YANMAR SERVICE NEWS

Subject	Rise of Exhaust Gas Temperature	No.: 16-2-G-08-001-O-rev.1 Aug. 2016	
Engine Model	6EY18(A)L(W)	Use	Marine Aux. Engines, Industrial
		Engine Nos.	_____

Fig.1 FO System Pressure Balance

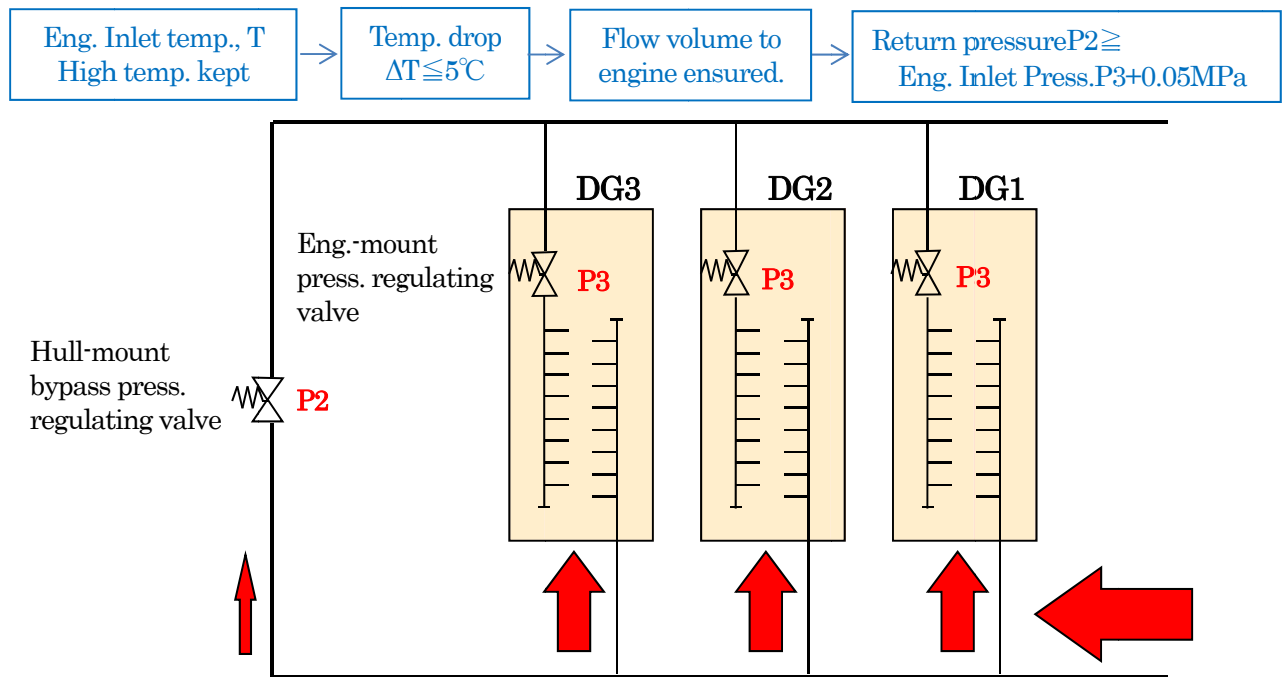
If the engine inlet temperature can't be improved with the adjustment of the setting, it is possible that the balance between the engine inlet pressure, P1, and the return pressure, P2, has collapsed, which has caused the fuel flow volume to the engine to be insufficient, (see Fig.1 below). In this case, adjust the respective pressure regulating valve to obtain the following pressure:

Pressure Setting of Hull-mount Pressure Regulating Valve, P2 \geq Engine Inlet Pressure, P3+0.05MPa

Fig.2 Increase of Clearance between Nozzle Ring & Exhaust Casing (Clearance Q)

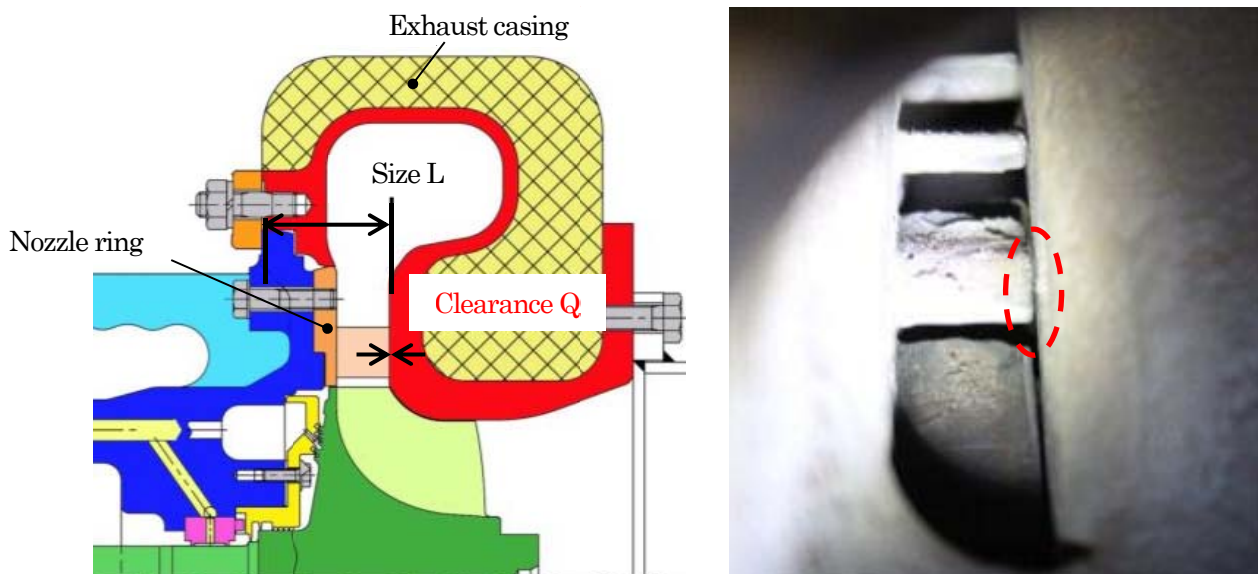
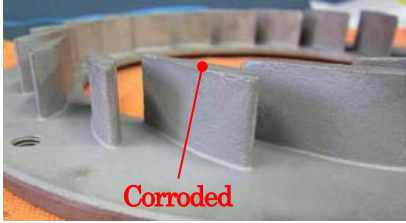
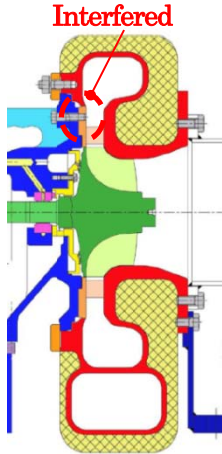
In the MET18 turbocharger, though after overhaul, exhaust gas temperature rose. The turbocharger manufacturer, Mitsubishi Heavy Industries Marine Machinery & Engine Co., Ltd, as a result of their survey on this problem, reported to us that the turbocharger performance dropped due to the increase of clearance between the nozzle ring and exhaust casing, (Clearance Q). Carbon was removed by the maintenance cleaning and the increased Q-clearance was exposed as a result. We project that this caused the exhaust temperature to rise soon after conducting maintenance.

Cause	Improvement
<p>【Corrosion Wastage of Nozzle Ring】 Nozzle ring caused corrosion wastage due to high oxidation corrosion, which contributed to increase the Clearance Q.</p> 	<p>【Nozzle Ring Material and External Diameter Change】</p> <ul style="list-style-type: none"> · In order to increase acid resistance, heat resistance and extreme temperature strength, the material was changed as follows: SS400(machined) → SCS1(casted) · In an aim to avoid interference caused by thermal expansion, the external diameter was diminished by 0.2mm. <p>【Discrimination】 Check the mfg. number punched on the nozzle ring surface and the rear casting surface.</p>
<p>【Nozzle ring rolled back】 As a result of FEM analysis, we found that the exhaust casing interfered with the nozzle ring outer circumference due to thermal expansion to cause distortion. However, this failure is corrected upon installing the exhaust casing. Accordingly, this factor gives only very small effect to the turbocharger performance drop.</p>  	<p>(Example) <u>JPC-1234</u> ↓ Improved type</p>  <p>Casting surface (4 positions)</p>  <p>【Applicable Engine No.】 7249~7251,7371~7385,7389~7403,7407~7409, 7416~7419,7433~7441,7446~7448,7452~7454, 7458~7466,7473~7490,7494~</p>

<p>【Distortion of Exhaust Casing】 We found that the distance between the installation flange face and the opposing nozzle face, (Size L in Fig.2), is distorted due to thermal stress for deformation, which contributed to increase the Q-clearance. However, the distortion was extremely small. Accordingly, this factor gives only very small effect to the turbocharger performance drop</p>	<p>【Exhaust Casing Material Change】 To increase strength against thermal stress, the material was changed as follows: FCD450 → Hi-Si ductile</p> <p>【Discrimination】 Check the mfg. number punched on casing.</p> <p>(Example) 15S-1257H ↓ Improved type</p>  <p>【Applicable Engine No.】 1840,1841,1855~</p>

As shown in the diagram below, it is possible to control the Q-clearance expansion by changing the present item to the improved nozzle ring. When the exhaust temperature rise is suspected due to Q-clearance expansion and performance drop, please inform to your Yanmar contact.

The exhaust casing needs not be replaced since the distortion was extremely small as mentioned above.
